Analysis of the Duke Energy 2020 Integrated Resource Plans

Introduction

Figure 1. Chart derived from combined data found in Tables 11-A and A-11 in the 2020 IRPs.⁷

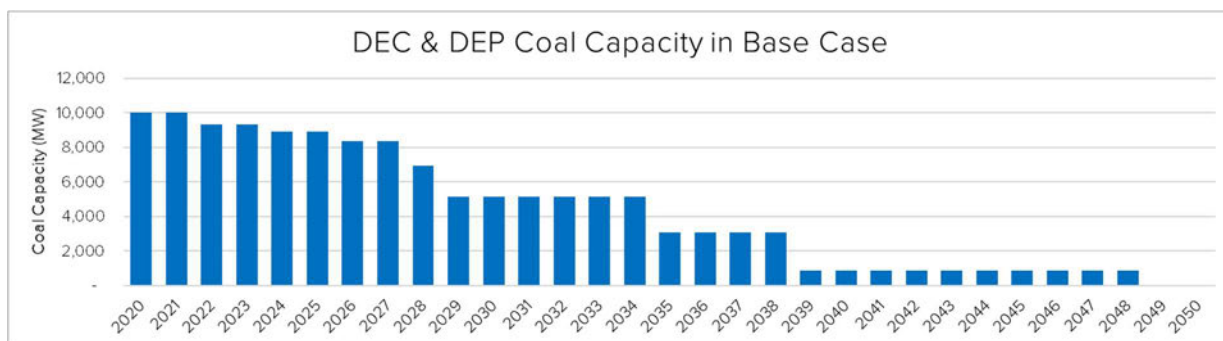
Strategen's analysis indicates that several of Duke's proposed retirement dates would extend the operation of certain coal assets well beyond what may be in the financial best interest of Duke's customers. Furthermore, the process by which Duke selected these retirement dates is flawed and deviates from sound planning principles. Finally, continuing to operate these assets for an extended period of time is inconsistent with the spirit of Governor Cooper's Executive Order No. 80⁵ and the North Carolina Clean Energy Plan.⁶
